**3GPP TSG CT Meeting #28
1st – 3rd June 2005. Quebec, CANADA.**

CP-0500049

Source: CT3
Title: CR to TS27.001 on Work Item TEI-6
Agenda item: 9.24
Document for: APPROVAL

27.001 CR 110 #rev 3 # Current version: 6.0.0

B.1.3.1.5 Transparent FNUR = 64kbit/s, including 3G-H.324/M (TCH/F9.6, TCH/F14.4, TCH/F32.0, UTRAN Iu mode))

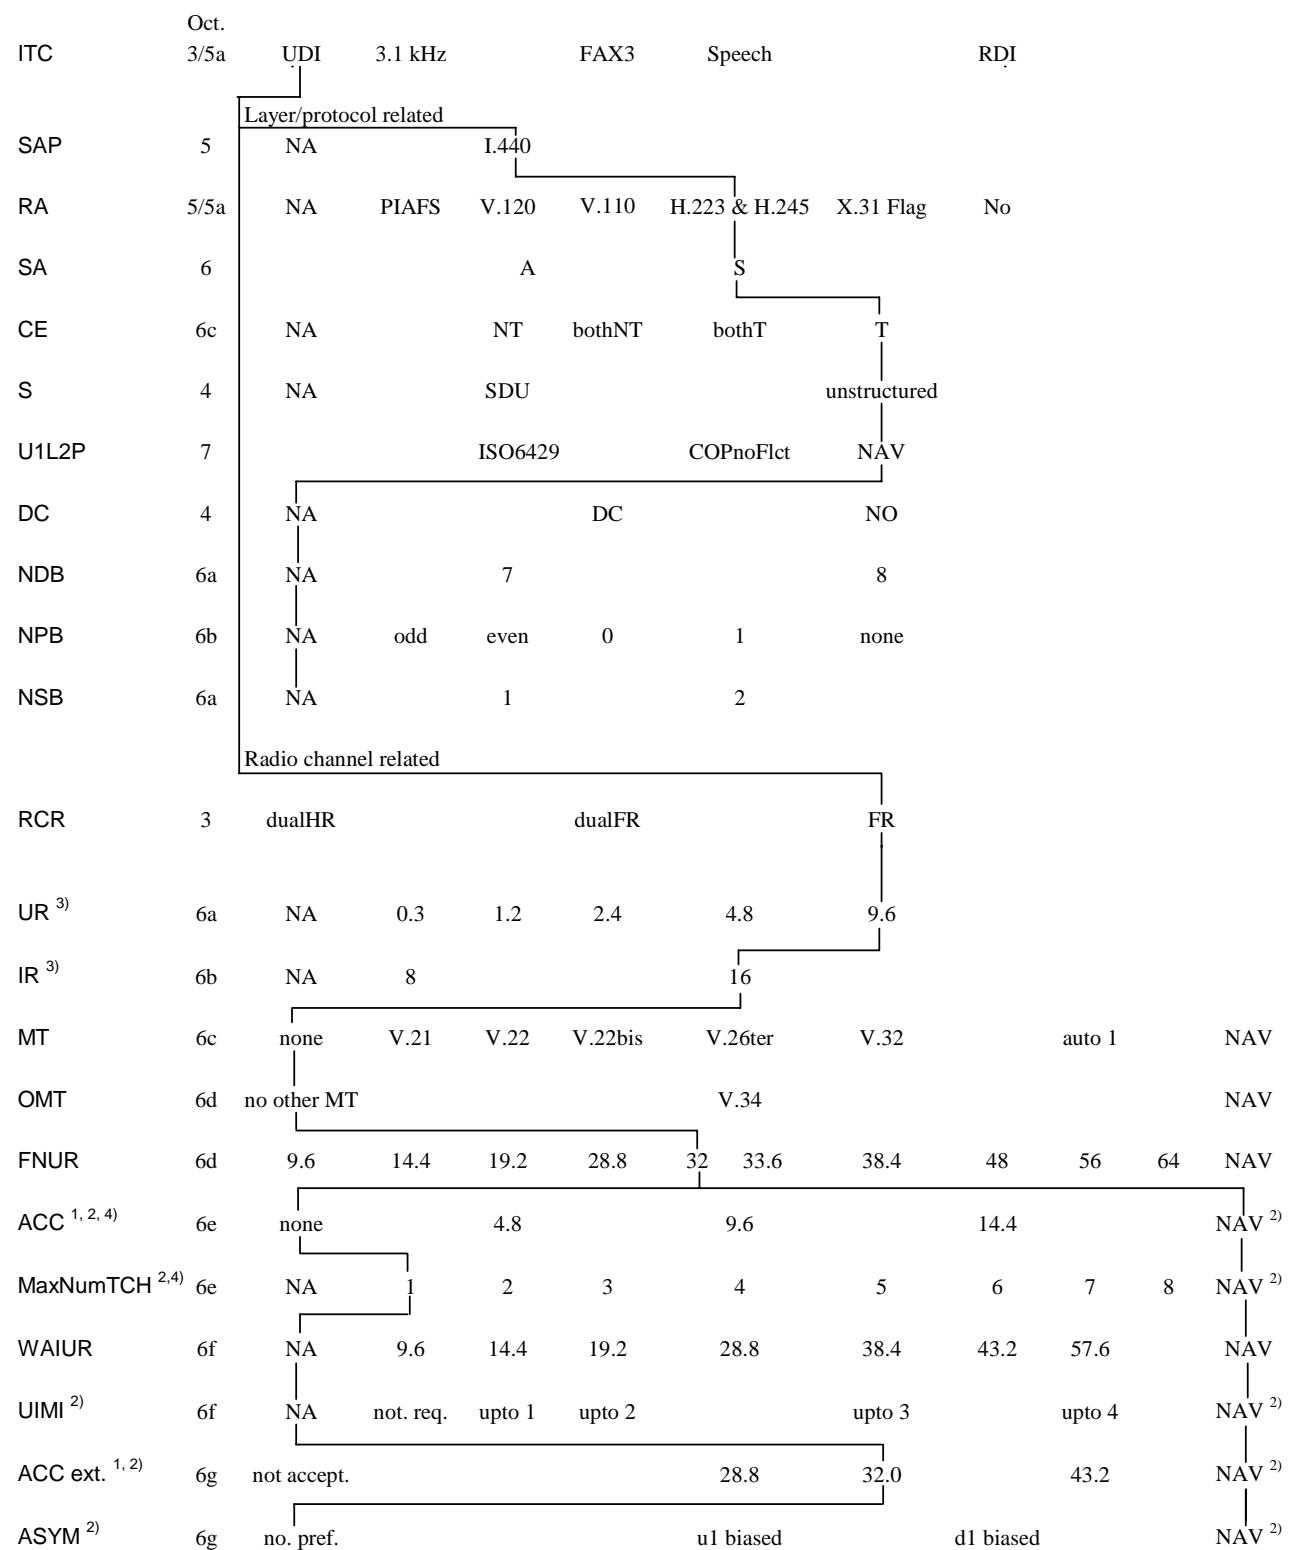
- 3) An MS not supporting GERAN A/Gb and GERAN Iu mode sets ACC to "none" and MaxNumTCH is set to "1 TCH". An MS not supporting GERAN A/Gb and GERAN Iu mode also sets ACCext (i.e. the extension bits of ACC parameter, see 3GPP TS 24.008 for its definition and values) and UIMI to zero if they are included in the PLMN BC-IE, i.e. UIMI is set to "NA" and the ACC parameter (including the ACCext bits) is set to the value "none" (all zeros).
- 4) The parameters FNUR and OMT are mandatory for this service.
- 5) If the call setup is started in A/Gb or GERAN Iu mode, the MS may indicate a need for a handover to another (e.g. UTRAN Iu) mode by setting all ACC fields to "none" (all zeros) and MaxNumTCH parameter to the value "one TCH" (zero). Similarly, while in another mode, the MS may inform the network that the MS does not support the requested service in A/Gb or GERAN Iu mode.

B.1.3.1.6 3G-H.324/M, FNUR=32.0 kbit/s (TCH/F32.0, UTRAN Iu mode)

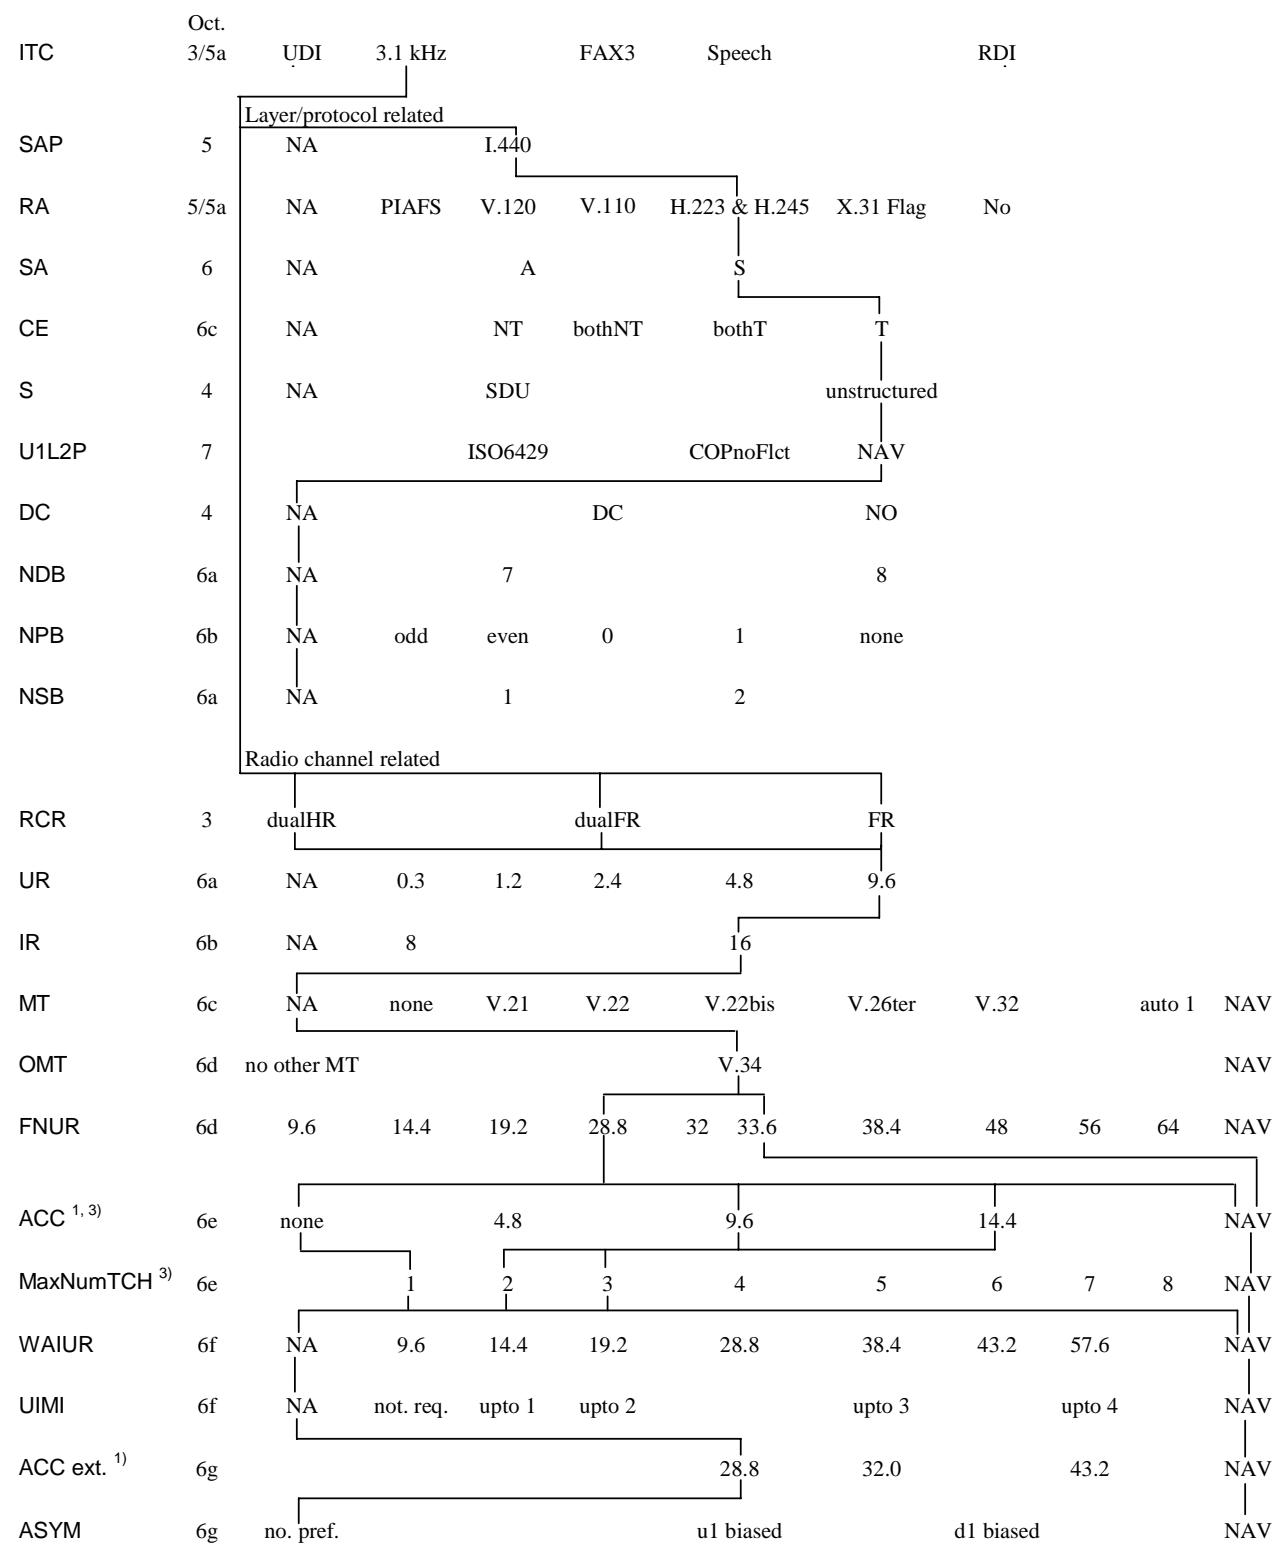
- 4) If the call setup is started in A/Gb or GERAN Iu mode, the MS may indicate a need for a handover to another (e.g. UTRAN Iu) mode by setting all ACC fields to “none” (all zeros) and MaxNumTCH parameter to the value “one TCH” (zero). Similarly, while in another mode, the MS may inform the network that the MS does not support the requested service in A/Gb or GERAN Iu mode.
